Our Case Number: ABP-312131-21

Re: Greater Dublin Drainage Project consisting of a new wastewater treatment plant, sludge hub centre, orbital sewer, outfall pipeline and regional biosolids storage facility
Townlands of Clonshagh, Dubber and Newtown, County Fingal and Dublin City

Date: 30 September 2022
Our ref: 3237/22/9
Your ref: ABP-312131-21

Re: Greater Dublin Drainage Project consisting of a new wastewater treatment plant, sludge hub centre, orbital sewer, outfall pipeline and regional biosolids storage facility in the Townlands of Clonshagh, Dubber and Newtown, County Fingal and Dublin City.

Figure 1 - Proposed Four Track Section looking North at Lands at Drumnigh.

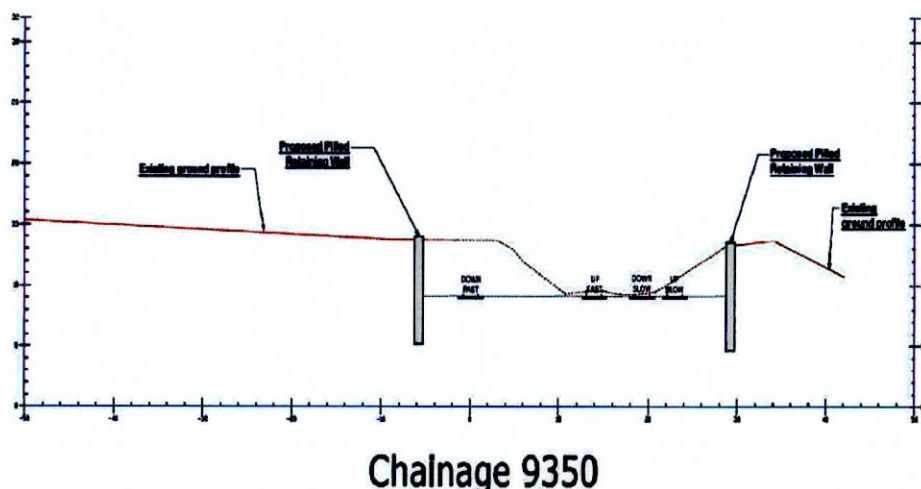
- 4) The DART+ Coastal Project (Northern Line) is underway and is currently at Phase 2 Project Concept, Feasibility & Option Selection. The works will involve track modifications to improve capacity, the installation of trackside overhead line equipment, construction of electrical substations including access roads, modifications to rail bridges, and any other modifications required to existing permanent way or railway systems infrastructure. An optioneering study to determine those works is on-going and this may determine the requirement for railway infrastructure additions or modifications in the vicinity of this proposed development. As a consequence of the estimated land take required to facilitate a works corridor for the track and bridge upgrade, no construction of access shafts should take place within an area 25m East and 40m West of the nearest running edge of the rail without the written permission of Iarnród Éireann, refer to Figure 1 below.

This includes the positioning of any access road, Soakholes / Percolation areas. Irish Water should consult with IE in relation to the output of this option selection study together with all other aspects of the DART+ Coastal Project.
